**From:** WELLS Russell (AREVA) [Russell.Wells@areva.com]  
**Sent:** Thursday, May 12, 2011 4:38 PM  
**To:** Tesfaye, Getachew  
**Cc:** Miernicki, Michael; CORNELL Veronica (EXTERNAL AREVA); WILLIAMSON Rick (AREVA); BREDEL Daniel (AREVA); BENNETT Kathy (AREVA); DELANO Karen (AREVA); HALLINGER Pat (EXTERNAL AREVA); ROMINE Judy (AREVA); RYAN Tom (AREVA); WILLIFORD Dennis (AREVA)  
**Subject:** Draft Revised Response to U.S. EPR Design Certification Application RAI No. 376, FSAR Ch. 3, Question 03.08.05-25  
**Attachments:** RAI 376 Questions 3.8.5-25 Response US EPR DC (DRAFT Rev. 2).pdf

**Request for Additional Information No. 376  
Question 03.08.05-25 Revision 2**

**Question 03.08.05-25:****Follow-up to RAI 155, Question 03.08.05-5**

**Figure 03.08.05-25-1—Foundation Modulus for High Frequency Soil Cases**

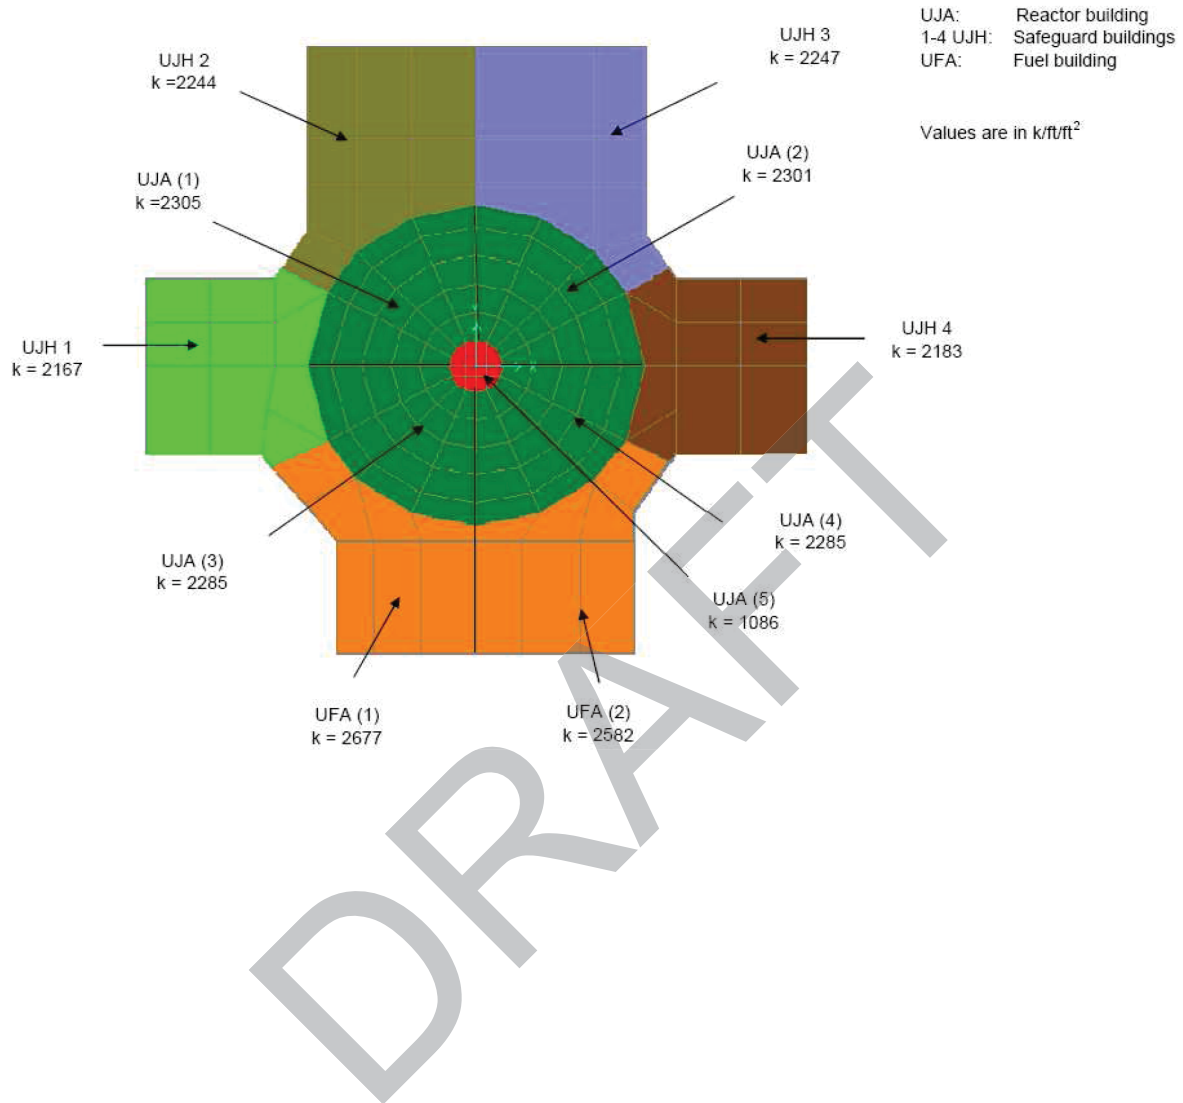
1. The response to Item 1 of this RAI states that the Gazetas equation was developed for dynamic, not static, conditions. Provide additional technical justification on why the Gazetas equation is appropriate for use in the equivalent-static seismic analysis of the NI structures, for the design of the basemat foundation, and for the evaluation of soil bearing pressures. This technical justification should include a comparison with results obtained from the SSI analysis, for all soil types considered appropriate for foundation support.

U.S. EPR FSAR Tier 2, Table 3.8-13 will be revised to reflect the current NI soil cases, and a new figure (Figure 3.8-145) will be added to show the soil spring distribution for the high frequency soil cases. U.S. EPR FSAR Tier 2, Section 3.8.5.4.2 will be revised to include the high frequency soil case spring distribution. U.S. EPR FSAR Tier 2, Sections 3.8.5.4.3 will be revised to provide the basis for the EPGB soil spring properties.

U.S. EPR FSAR Tier 2, Table 3.8-19 and Figure 3.8-145 will be added as described in the response and indicated on the enclosed markup.

The high frequency soil case (i.e., hfub, hfbe and hflb) static distributions are based on a site-specific rock site distribution where a foundation modulus is determined for each NI common basemat structure (see Figure 3.8-145).
